IN THE DRAWINGS

REMARKS

This Amendment is submitted in response to the Office Action dated June 13, 2005. In the Office Action, the Patent Office objected to the drawings because reference numerals 19 and 99 are not shown. The office requested that corrected drawings be submitted in compliance with 37 CFR 1.121(d). The Office further objected to Claims 1-3 because of informalities. Moreover, the patent office rejected Claims 1-3, 6-8 and 13 under 35 U.S.C. §102(b) as being anticipated by *Lautin* (United States Patent Number 2,964,937). Additionally, the patent office rejected Claims 1-3, 6-8 and 13 under 35 U.S.C. § 102(b) as being anticipated by *Isenmann* (United States Patent No.: 3,979,934); and rejected Claims 1-3, 6-8 and 13 under 35 U.S.C. § 102(b) as being anticipated by *Klose* (United States Patent No.: 4,422,315). Finally, the patent Office rejected Claim 12 under 35 U.S.C. § 103(a) as being unpatentable over *Isenmann* in view of *Ros* (U.S. Patent No.: 4,713,951).

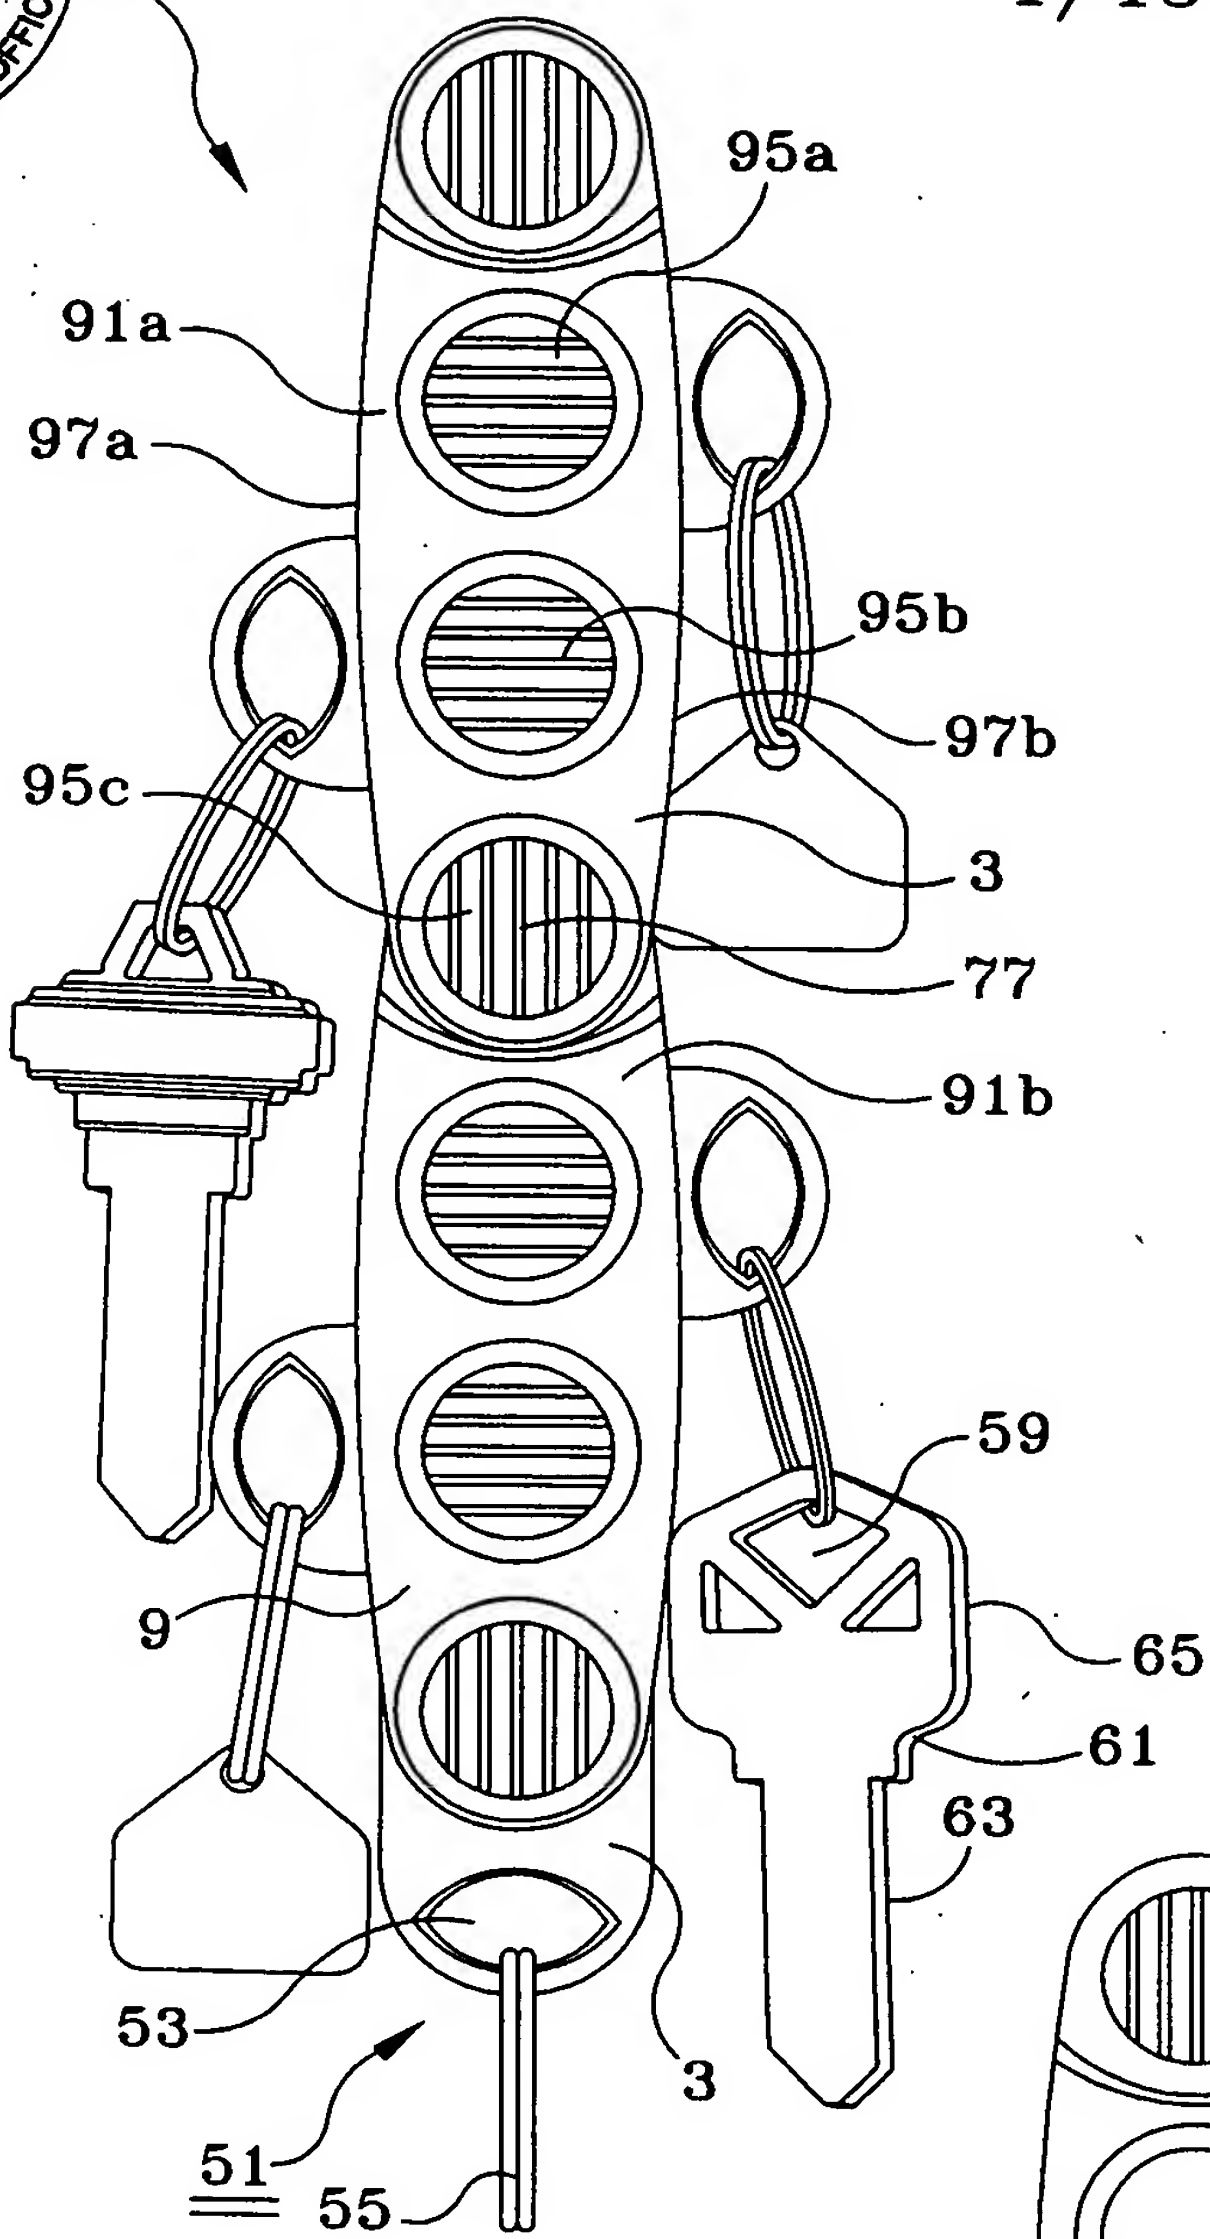
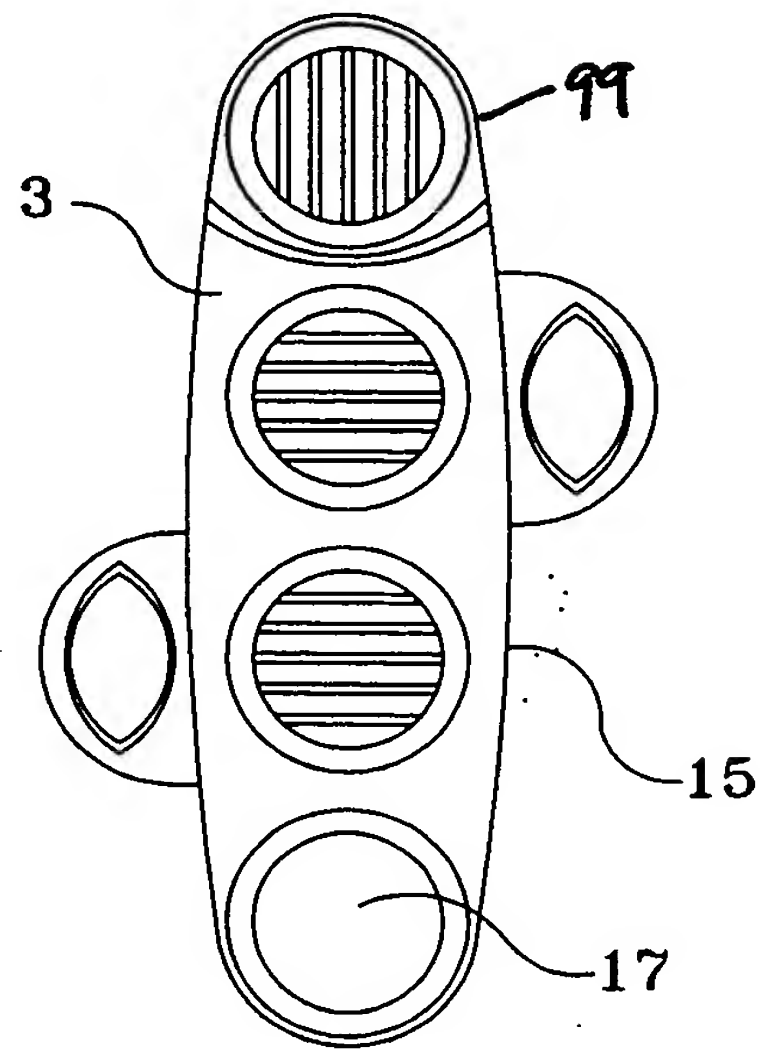
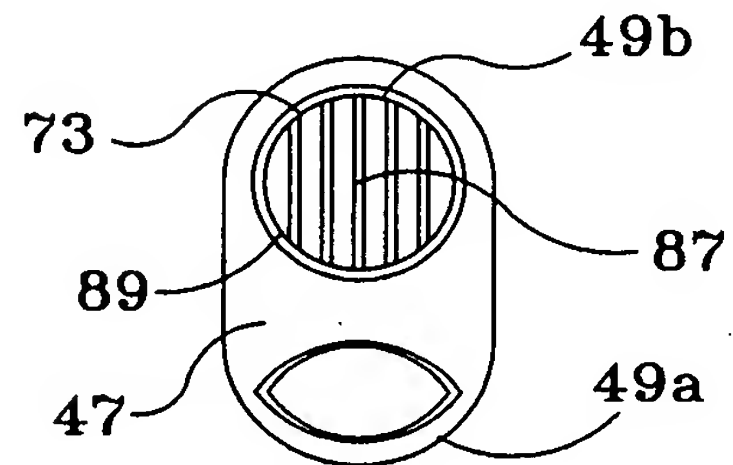
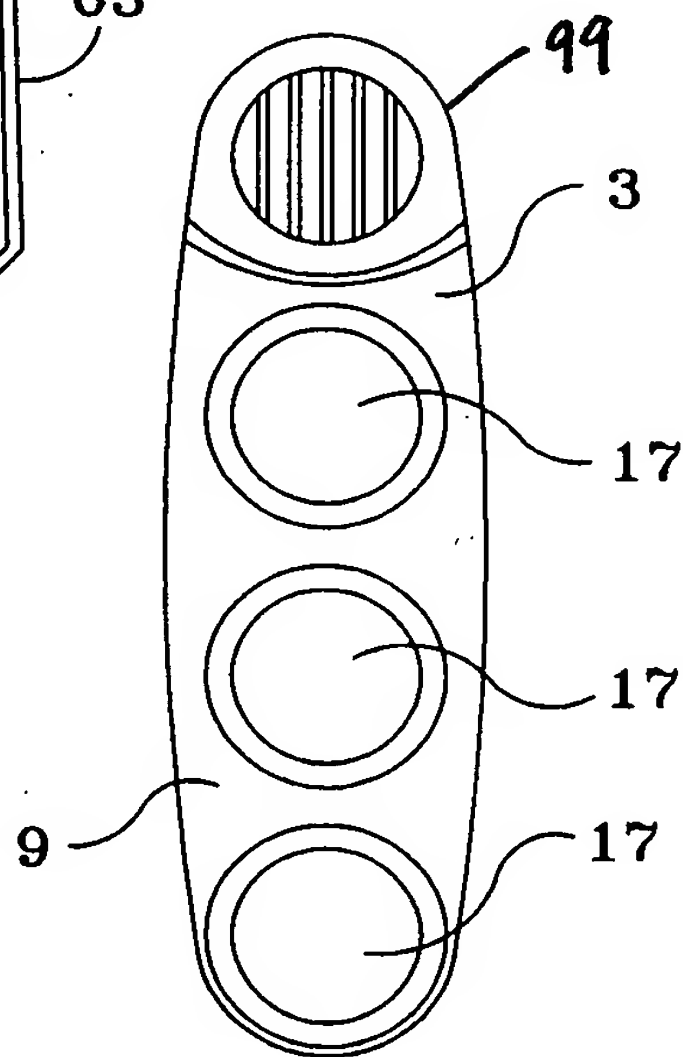
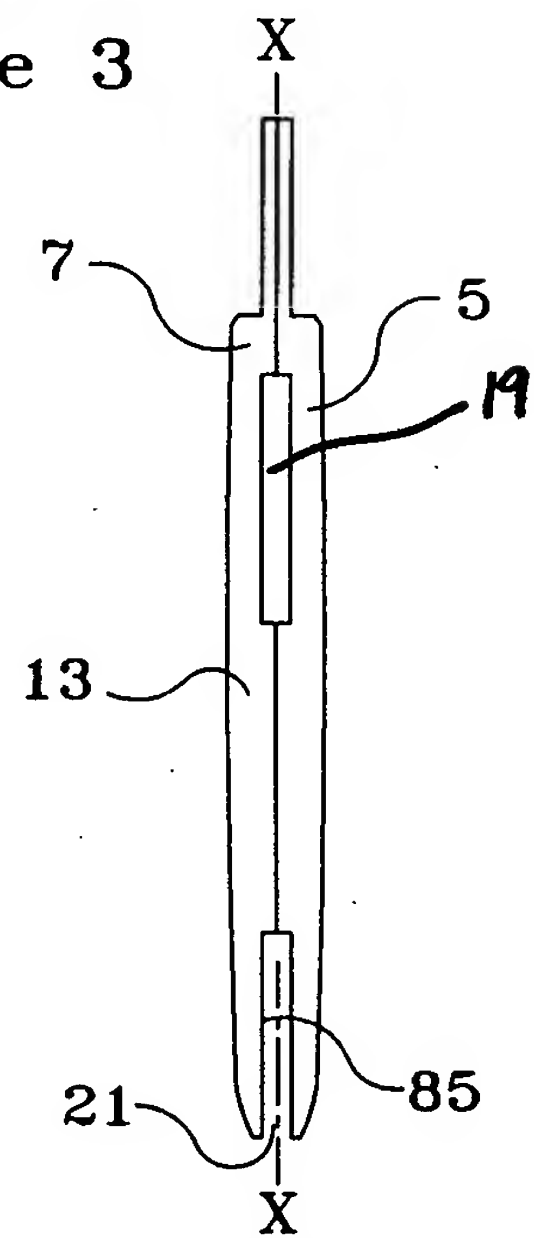
The Patent Office objected to the drawings because reference number 19 (page 7, line 11) and reference numeral 99 (page 10, line 18) are not shown. The Patent Office requested that corrected drawing sheets in compliance with 37 CFR 1.121(d) be submitted. Applicant submits herewith corrected drawings showing reference numerals 19 and 99. Applicant respectfully

Enclosed are Figures 1-5 with the corrected drawing sheets shown in red in compliance with 37 C.F.R. 1.121(d). The drawings are labeled as REPLACEMENT SHEETS in compliance with the rules. The drawings do not introduce any new matter into the application.

submits that the objection has been overcome. Notice to that effect is requested.
